# SERVICE BULLETIN

NEW CLUTCH  
RELEASE  
BEARING  
AND  
SLEEVE  
ASSEMBLY

No. 63-112

GROANING  
NOISE WHILE  
DEPRESSING  
CLUTCH  
PEDAL

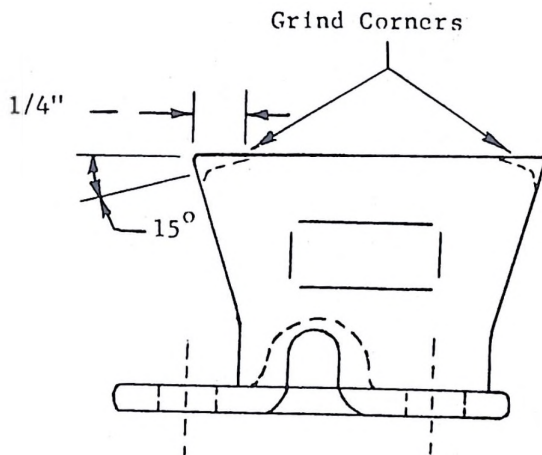
If you encounter a groaning noise while depressing the clutch pedal on a 1963 Plymouth or Valiant car equipped with a manual transmission, it may be caused by interference at the corners of the clutch release fork pivot. The corners have been relieved on all 1964 models.

The same correction can be accomplished on 1963 models, by modifying the "L" shaped pivot as shown in the following sketch:
